County of San Diego  
Planning & Development Services  
**BUILDING DIVISION**

ACCESSIBILITY CORRECTION LIST

Multifamily Housing

**Parking Facilities**

FIGURE 11A-2B  
SINGLE AND VAN ACCESSIBLE PARKING STALLS

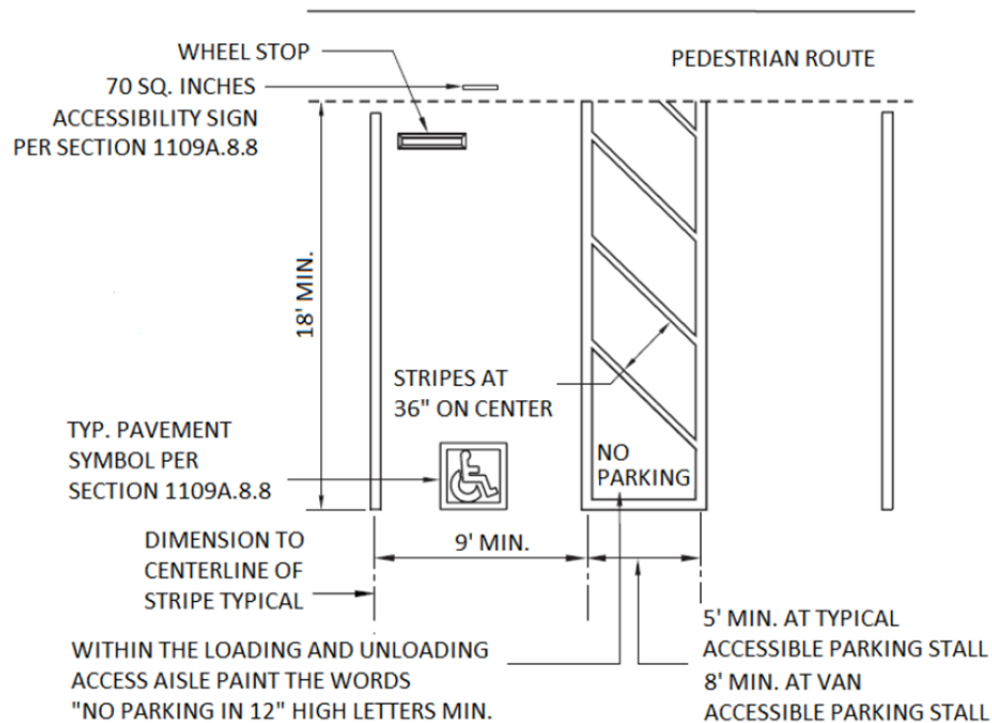
14. Where individual accessible parking spaces are provided, dimension the following per CBC Figure 11A-2B:

☐ Minimum 9-foot-wide by 18-foot-long parking stall

☐ Minimum 5-foot-wide by 18-foot-long access aisle on passenger side of vehicle

**Exception:** Minimum 8-foot-wide by 18-foot-long access aisle required on passenger side of van accessible spaces

**FIGURE 11A-2A  
DOUBLE PARKING STALLS**

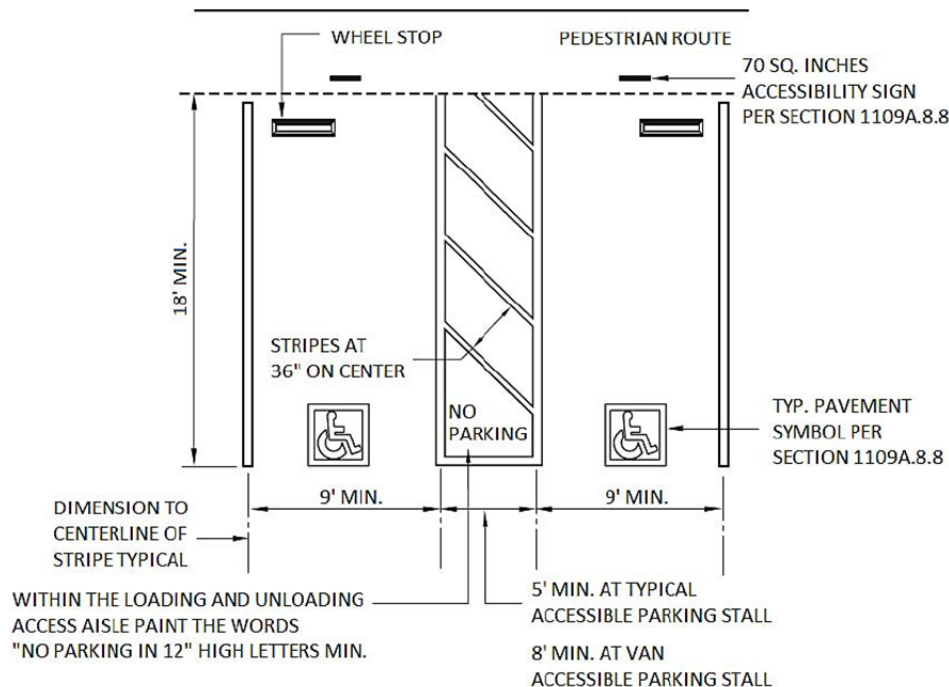
15. Where dual accessible parking spaces are provided, dimension the following per CBC Figure 11A-2A or CBC Figure 11A-2C:

- Two minimum 9-foot-wide by 18-foot-long parking stalls
- Minimum 5-foot-wide by 18-foot-long access aisle between parking stalls

**Exception:** Minimum 8-foot-wide by 18-foot-long access aisle required on passenger side of van accessible spaces
